Access Compliance Report

Public Rights-of-Way

(Curb Ramps)

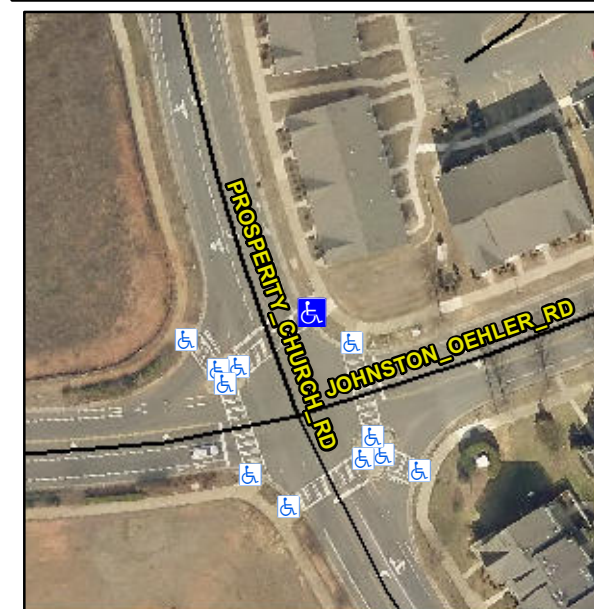
Intersection ID: 44723	Main Street: PROSPERITY_CHURCH_RD	Cross Street: JOHNSTON_OEHLER_RD	Location: NE
ADA ID: 9D586B0B3B27	Ramp Type: Perp	Initial Pass/Fail: Fail	Overall Compliance: No
Severity Score: 10			
Codes/Mitigation Info/Possible Solution		Field Measurements/Component Compliance

R304.5.1, R304.5.3

Compliance	Description	Data	Compliance	Description	Data
N/A	Ramp Length (in)	96.0	Yes	Ramp Slope (%)	5.3
No	Ramp Width (in)	41.0	No	Ramp XSlope (%)	4.4
N/A	Flare Type LT	N/A	N/A	Flare Type RT	N/A
N/A	Flare Slope LT (%)	N/A	N/A	Flare Slope RT (%)	N/A
N/A	Flare Traversable LT?	N/A	N/A	Flare Traversable RT?	N/A
N/A	Landing Length (in)	N/A	N/A	DWS Provided?	N/A
N/A	Landing Width (in)	N/A	N/A	DWS Contrast?	N/A
N/A	Landing Slope (%)	N/A	N/A	DWS Length (in)	N/A
N/A	Landing X Slope (%)	N/A	N/A	DWS Full Width?	N/A
N/A	Landing Curb? (Y/N)	N/A	N/A	DWS Offset (in)	N/A
N/A	Shared Landing?	N/A			
N/A	Gutter Ponding?	N/A	N/A	Gutter Slope (%)	N/A
N/A	Gutter Lip Ht (in)	N/A	N/A	Gutter X Slope (%)	N/A
N/A	Painted X Walk1?	Yes	N/A	Painted X Walk2?	N/A
	X Walk 1 Direction	To SW		X Walk 2 Direction	N/A
N/A	X Walk 1 Width (in)	108.0	N/A	X Walk 2 Width (in)	N/A
	X Walk 1 Slope (%)	0.9		X Walk 2 Slope (%)	N/A
	X Walk 1 X Slope (%)	2.7		X Walk 2 X Slope (%)	N/A

Remove & Replace Entire Ramp.
